**Report to the Chairman and Members  
of the North Central Area Committee**

Notification of Intent to submit a Part 8 Planning Application to allow for a modification to the Flood Defence Wall opposite St. Anne's Park.

**Christopher K. Manzira  
Acting Senior Engineer  
Environment and Transportation Department**

**March 2017**

Drawing No: SEA WALL WORKS  
 PLAN LAYOUT

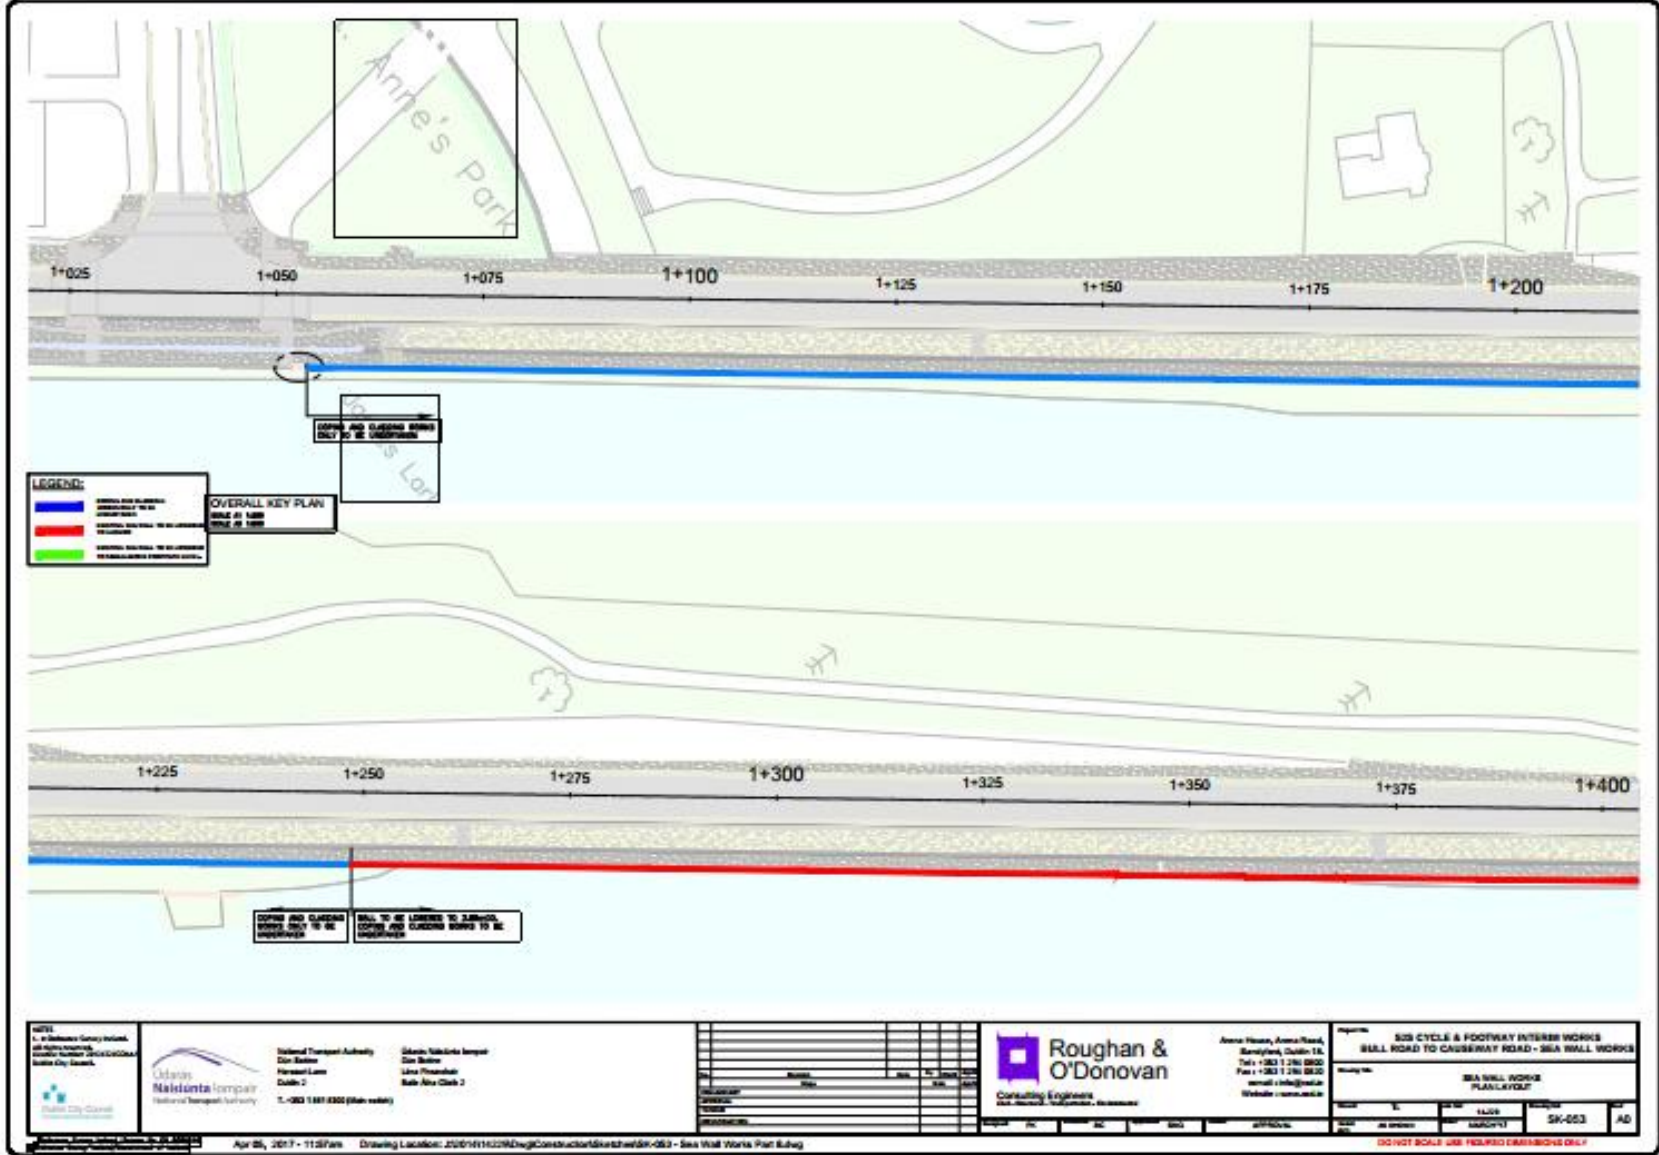
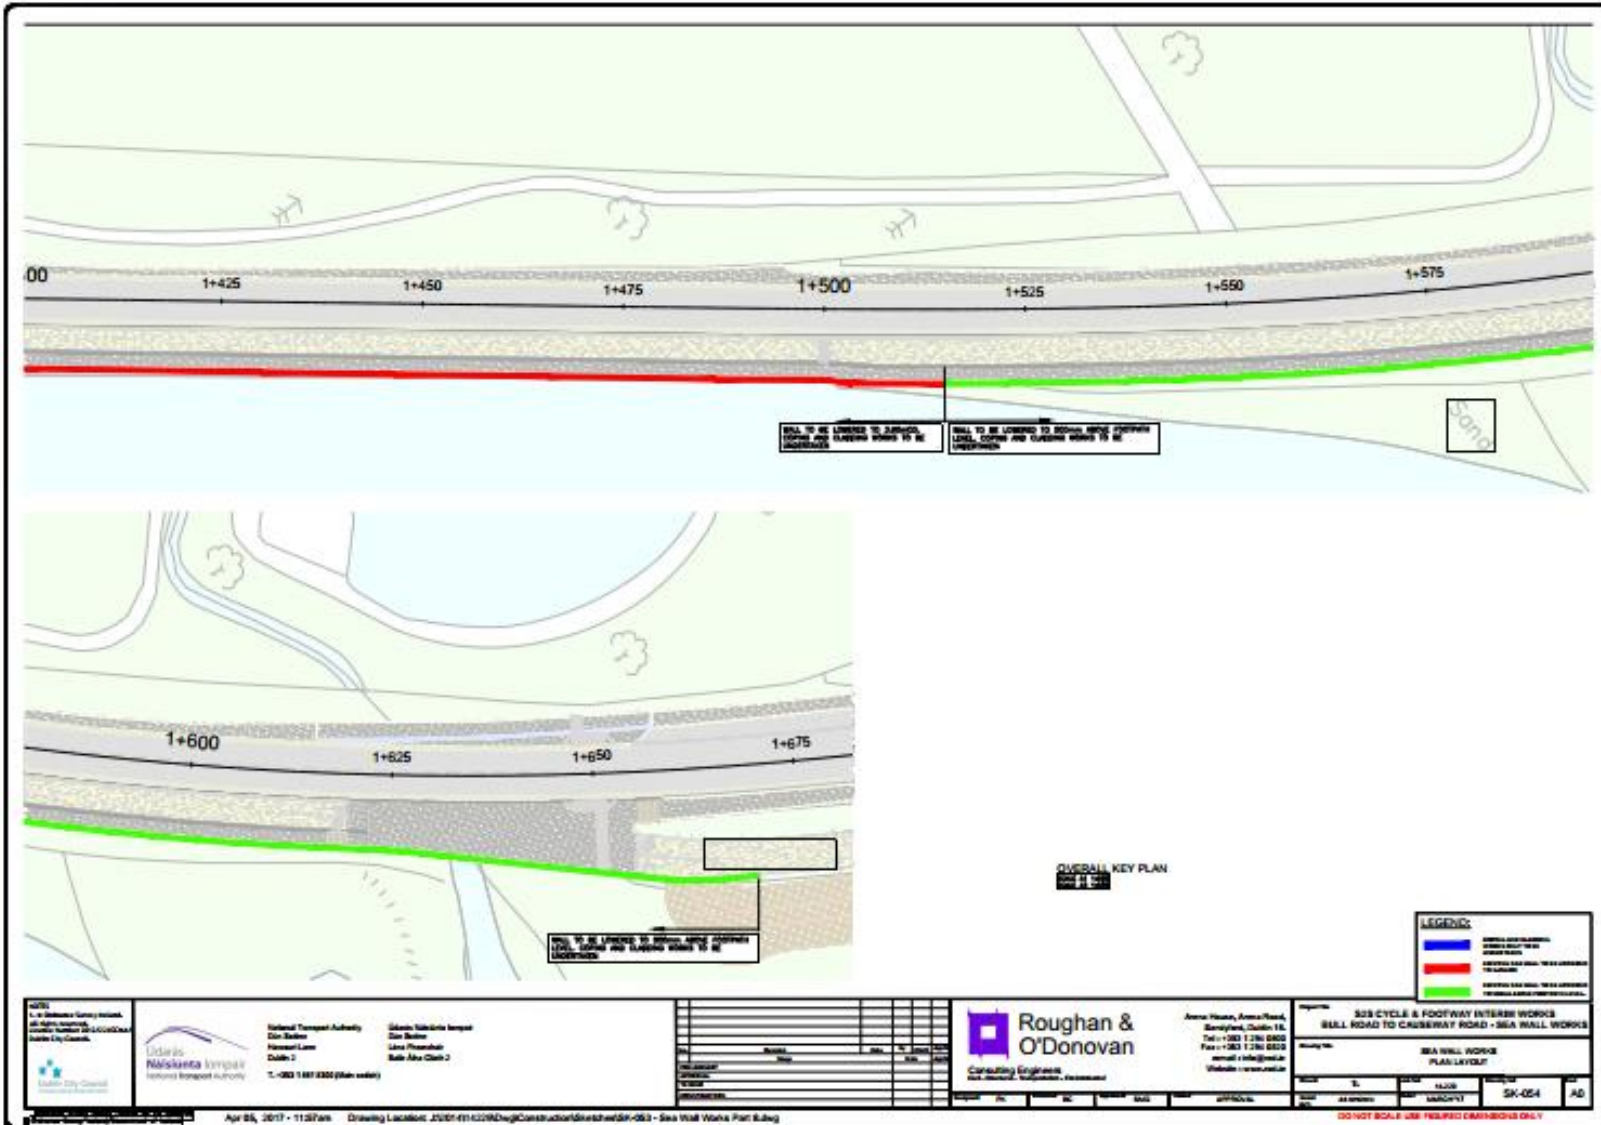
It is now proposed to lower approximately 470m (marked in red and in green) of the flood defence wall opposite St. Anne's Park, from the start of the wall opposite the ponds to opposite the Gate Lodge (Chainage 1+250) by up to 300mm. The lowering of the wall by 300mm will mean that this portion of wall will only provide flood protection against a 100 year tidal event rather than the national standard of the 200 year tidal event.

In order to provide some protection against pedestrians falling into the lagoon, it is proposed that the minimum height of wall should be knee high, that is 500mm. This will mean that a section of the wall, approximately 180m in length (marked in green, from chainage 1+510 to the start of the wall at the ponds) will be lowered by less than 300mm.
